IEEE 802.3de Time Sync for Pt-to-Pt SPE: Summary of half-duplex issues and potential changes needed

Comments from D2.0

Figure 99-5—Transmit Processing state diagram

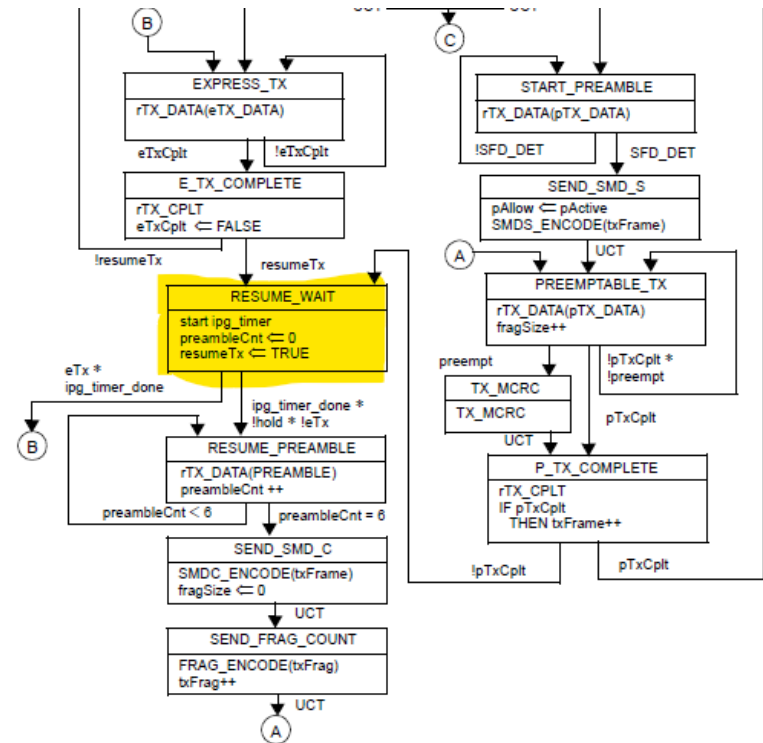
59	Kabra, Lokesh	Synopsys Inc	99	99	14		T	Similarly, impact of collisions/retransmission of fragments in not fully considered/explained in Transmit Processing. For example, if collision occurs during transmission of preemptable fragment, then Transmit processing remains in PREEMPTABLE_TX state because pTxCplt = FALSE. In such a case, express packet will remain in queue and gets delayed until the retransmission of the fragment is complete after the random back-off. Is this intended?	Transmit Processing to be updated for handling of collisions/retransmission of fragments in half-duplex mode	REJECT. Insert Editor's note at P14 L18: Editor's Note (to be resolved prior to close of WG ballot) - Issues have been raised with regards to the need for additional changes in Transmit and Receive Processing for 10BASE-T1S point-to-point half duplex (other half-duplex PHYs being out of project scope). See comments i-58 and i-59 for more detail. Comments do not provide sufficient detail to resolve. Presentations and further comments to with specific changes to resolve issues are solicited.	R

- Late collisions when pMAC transmitting continuation fragment
 - > Hold on to the media between when eMAC finishes transmitting and pMAC resumes non-first fragment.
 - > Carrier extension in the RESUME_WAIT state
 - > Could use COMMIT
 - > Need to specify way to signal it – CI 22 primitives are insufficient
